FTI-TLP4: Vehicle Coverage and Preparation Notes

FTI-TLP4 Harness Bulletin: Mis-Wired Lock Connector

COM-BLADE-AL(DL)-TL6-EN

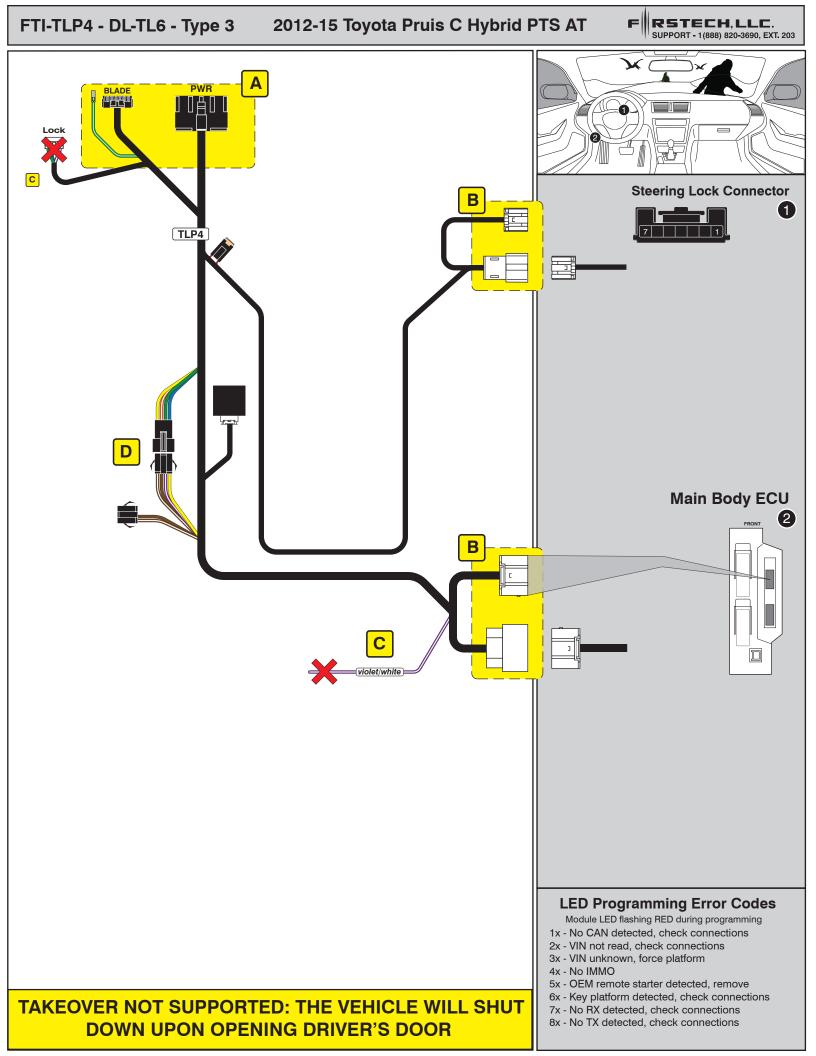
Issue: A review of the latest samples of **FTI-TLP4 T-harnesses** has revealed a misplaced trunk output wire in the 6-pin Lock Accessory Connector requiring that the wire be relocated to the correct position, to ensure safe operation when used. Using the harness without addressing the issue will result in failed trunk/hatch control, and possible damage to the vehicle BCM.

Correction: The harness purple/white wire in the latest production run of FTI-TLP4 harnesses has been inserted in the position normally used for the +12V power connection in the accessory harness. Before completing the installation, the installer must relocate the harness purple/white wire to the correct position, 1 space inward on the 6-pin connector, see illustrations below in Fig. 2.

To relocate the terminal, using a fine pick or Olfa type knife, depress the terminal locking barb and pull the purple/white wire from the connector housing. Once the terminal has been removed from the housing, again using the pick or knife, lift the locking barb about 1/16" (1.5 mm) and reinsert the terminal in the correct position. If upon initial examination of the harness the lock accessory connector looks like the illustration in Fig. 2, no modification is necessary, the wire is in the proper position.
